### ADDENDUM No. 3

#### Montello Street at Route 58 Re-alignment Project Carver, Massachusetts

August 12, 2021

The following Addendum No.3 is hereby issued to the Bid Documents entitled, “Montello Street at Route 58 Re-alignment,” dated July 21, 2021.

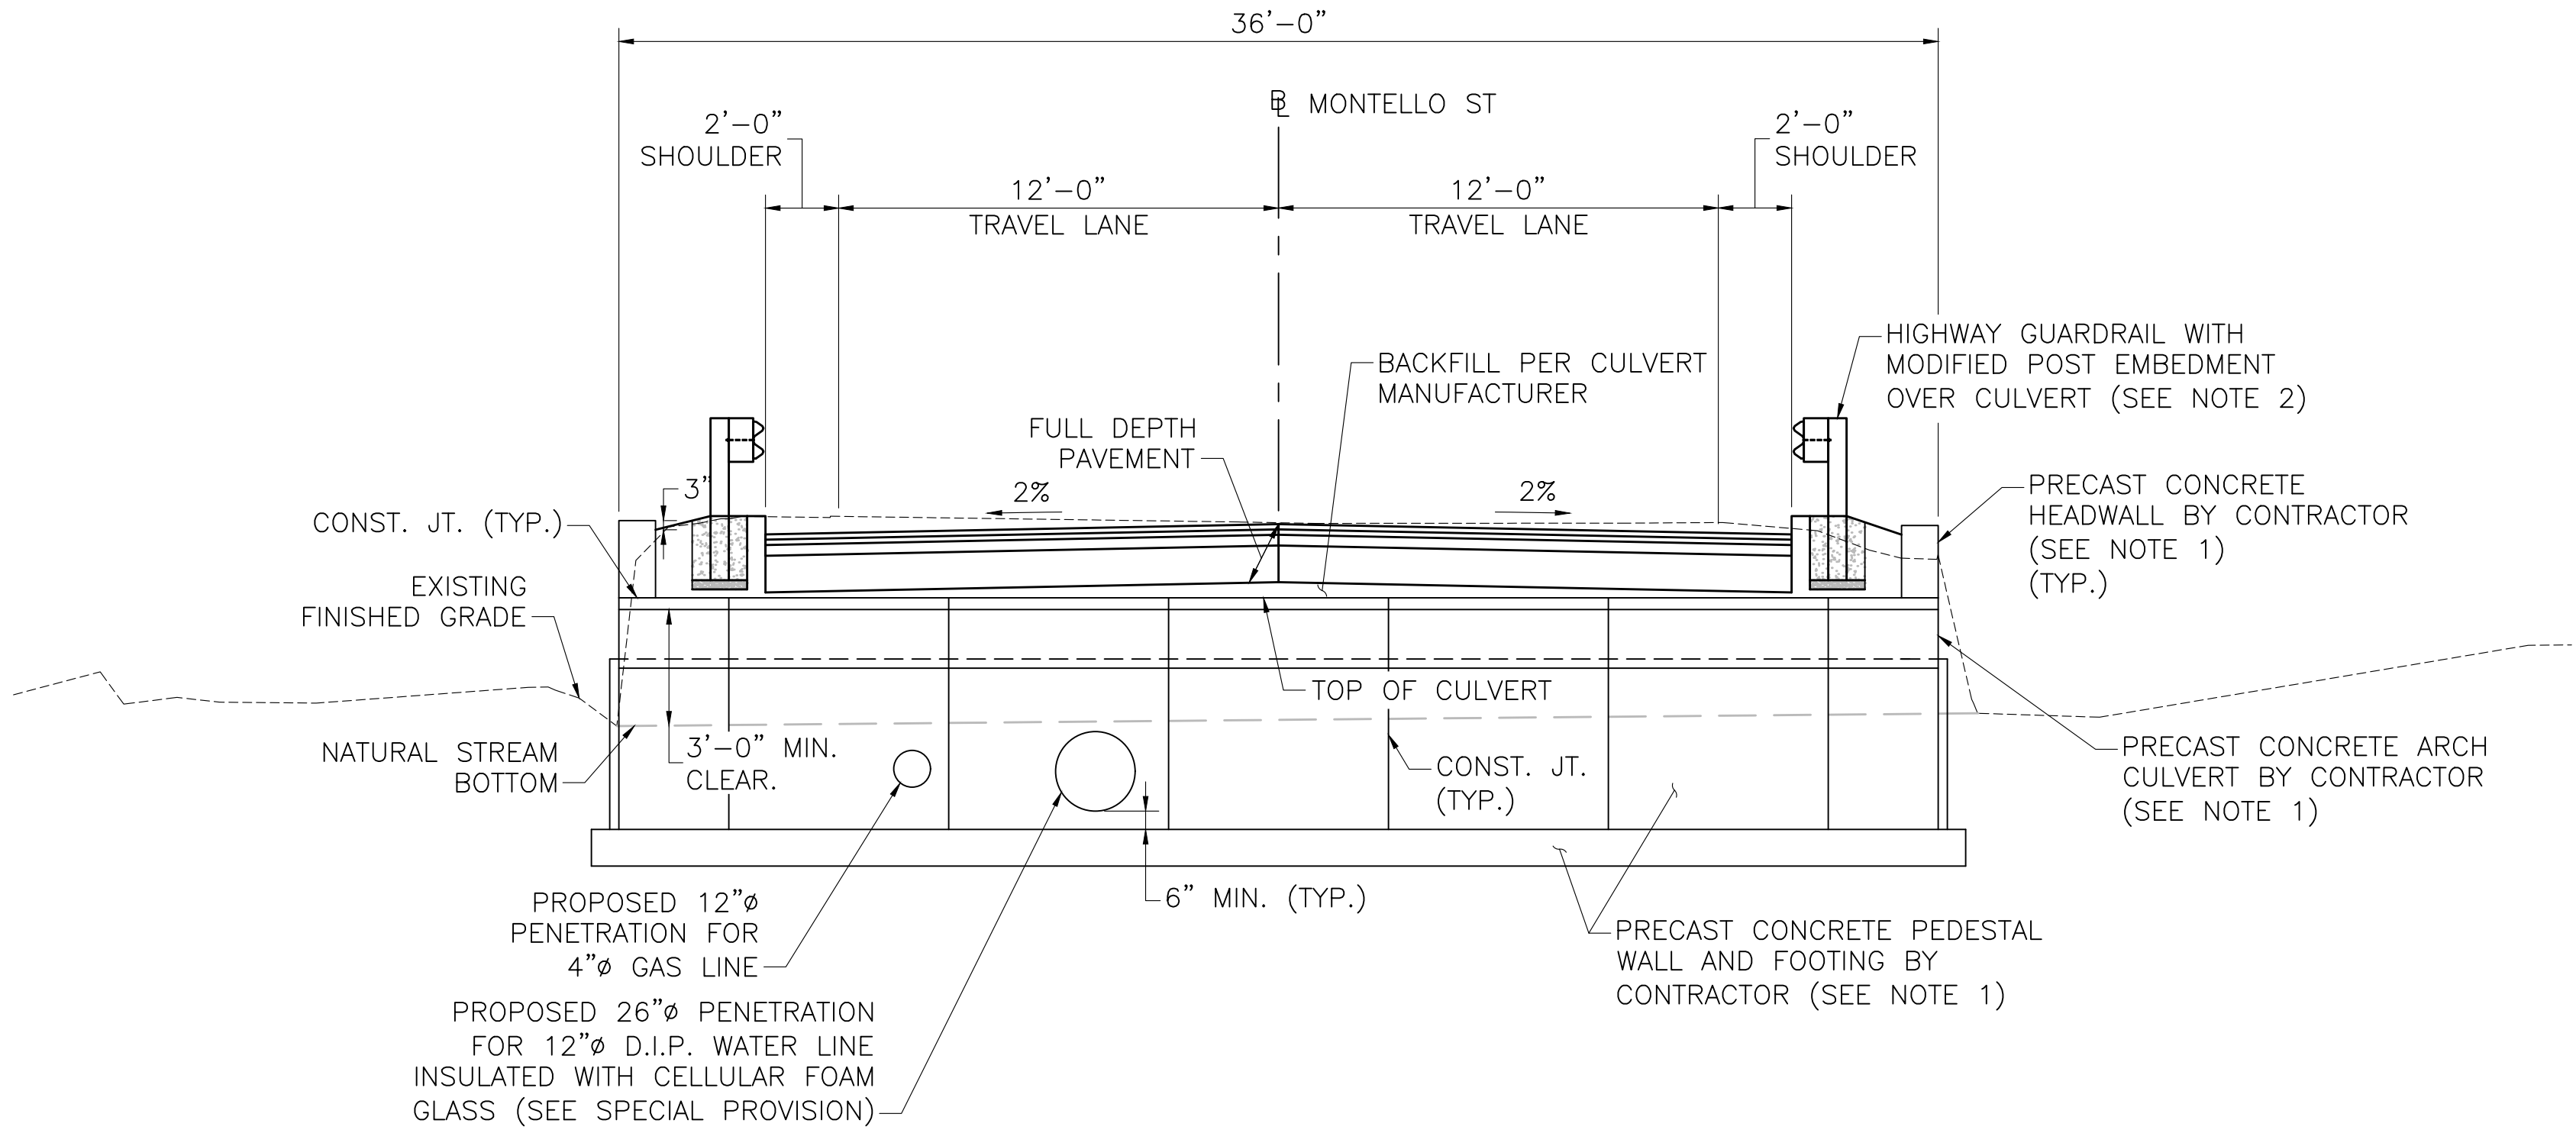
Q: *Drawing Sheet 37, General Notes, Demolition and construction, states “contaminated waste shall be disposed off-site at approved facilities”.*

- a. *Are any contaminated soils anticipated, and if so what type? Please Quantify.*
- b. *If encountered, how will contaminated soils be paid?*

A: This is a general construction note. There are no known contaminated soils in the project area and, as such, they have not been factored into the bid documents. Please see the geotechnical report prepared by Sanborn Head attached to the bid documents.

**LONGITUDINAL SECTION**  
SCALE:  $\frac{1}{4}" = 1'-0"$

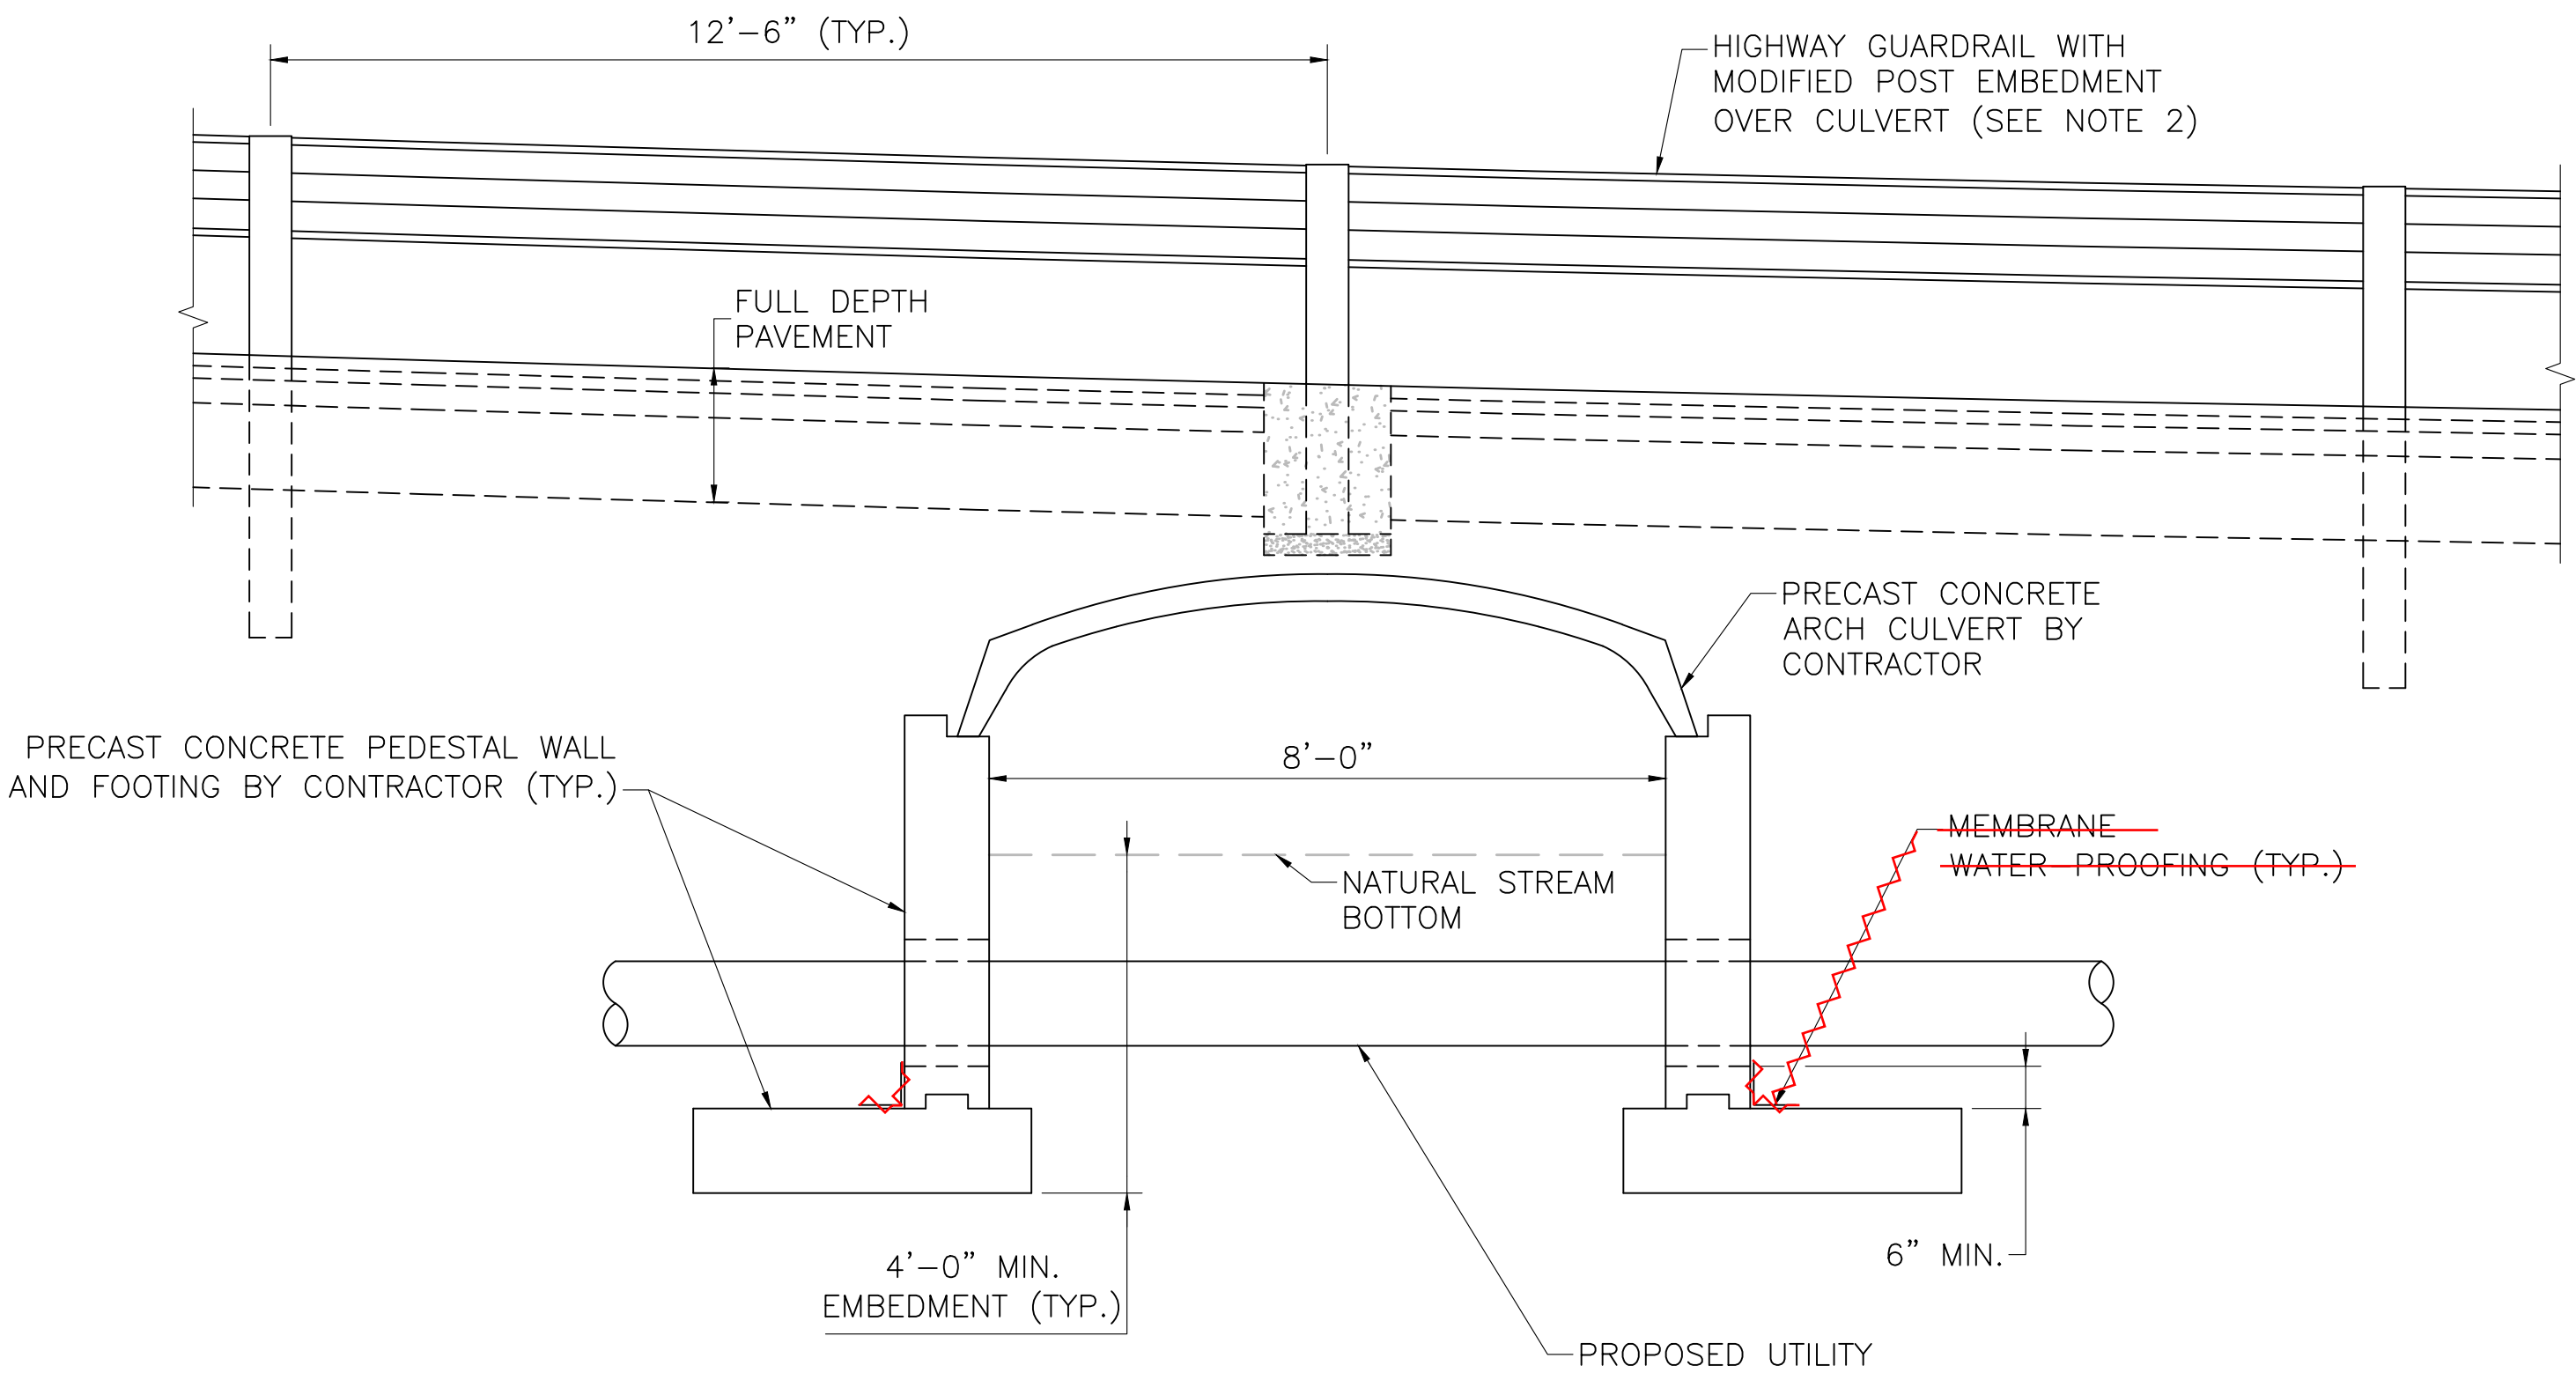
*Q: Item #995.01- Precast Concrete Arch Culvert*

*At pre-bid meeting, a 4' x 8' precast box culvert was stated as intent of design with the utilities under the culvert. This is not what the project plans are showing. Plans show concrete footings, parapet/abutment walls, wingwalls and footings. The specifications state that all of the culvert work is “precast” (footings, wall, headwalls, wingwalls, and all footings). We need clarification ASAP as to what the intent of culvert design is. Is any of the concrete work cast in place? Specs state design by GC for this work. Need to know what is required? Is a 4'x8' precast box culvert acceptable with the utilities under the culvert in sleeves? Is an open bottom 4' x 8' culvert acceptable with the utilities under the culvert in sleeves, and if so, what is the surface treatment for the stream bottom inside the culvert? Where is damp-proofing and membrane waterproofing required. Please provide clarification ASAP.*

A: Please see sheets 37 through 40 in the plans for culvert drawings and details. The proposed culvert shall be made of precast concrete. The culvert width shall be a minimum of 8' and the opening from the top of the natural stream bed to the inside top of the culvert shall be a minimum of 3' as shown on the plans. An open-bottom box culvert is acceptable – the top of the culvert does not need to be arched as long as the minimum opening dimensions of 3' by 8' are met or exceeded (hydraulic opening size cannot be smaller than shown). The utility sleeves shall be slotted through the culvert walls as shown on the plans. Bottom of precast footings shall be 4'-0" below finished grade, as shown on sheet 38 to 39 of the plans. Damp-proofing is required along the vertical face of the pedestal walls to the top of footing and horizontally 2'-0" along the top of footing. Membrane waterproofing is not required. **Bidders shall replace Plan sheet 39 with the revised Plan sheet 39, attached. Bidders shall also replace sheet 138 of the Special Provisions with the revised sheet 138, attached.** See Addendum No. 2 for additional information on the culvert.

1. PRECAST CONCRETE ARCH CULVERT, PEDESTAL WALLS, AND FOOTINGS TO BE DESIGNED BY CONTRACTOR. ELEVATIONS MAY VARY DEPENDING ON CONTRACTOR DESIGN.
2. GUARDRAIL POST SHALL BE MODIFIED IN ACCORDANCE WITH MASSDOT DRAWING NO. 400.5.1 "ENCASED POST FOR SHALLOW MOUNT," DATED OCTOBER 2017.
3. THE FACTORED BEARING PRESSURE SHALL BE DETERMINED BY THE CONTRACTOR PER AASHTO LRFD BRIDGE DESIGN SPECIFICATIONS.

THE FACTORED BEARING RESISTANCE SHALL BE CALCULATED AS A FUNCTION OF THE WIDTH OF THE FOOTING AS DESCRIBED IN THE GEOTECHNICAL MEMORANDUM DATED FEBRUARY 12, 2021 BY SANBORN, HEAD & ASSOCIATES, INC. FACTORED BEARING RESISTANCE IS THE PRODUCT OF THE NOMINAL BEARING RESISTANCE AND A RESISTANCE FACTOR OF 0.45.
